Access Compliance Report Public Rights-of-Way (RR Crossings)

Intersection ID: 10031407	Main Street: MCALPINE_STATION_DR	Location: N/A
ADA ID: 811C494C664B	Overall Compliance: No	Severity Score: 0.0
Codes/Mitigation Info/Possible Solution		Field Measurements/Component Compliance

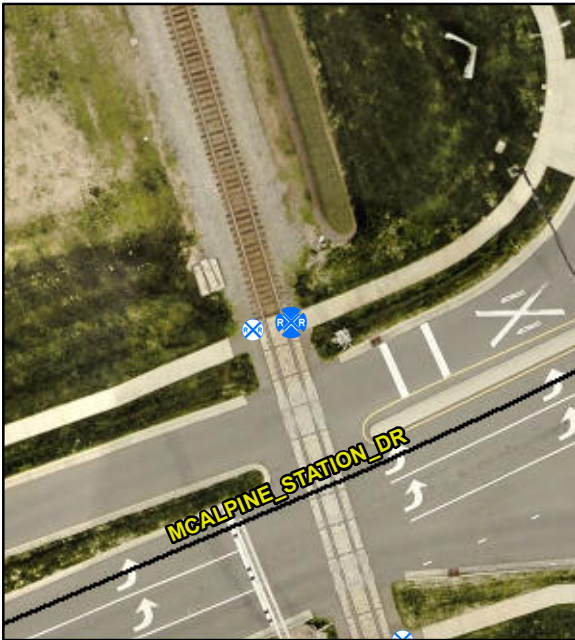
**Install Detectable Warning System.
Provide Pedestrian Gate. Remove &
Replace Walking Surface Adjacent
to Rail.**

Compliance	Description	Data
No	DWS Provided?	No
N/A	DWS Contrast?	No
N/A	DWS Width (in)	No
N/A	DWS Length (in)	N/A
N/A	DWS Offset (in)	N/A
No	Pedestrian Gate?	No
N/A	DWS Outside Gate?	No
N/A	Rail Type?	Freight
No	Flangeway Gap (in)	3.0
Yes	Sidewalk Width (in)	59.0
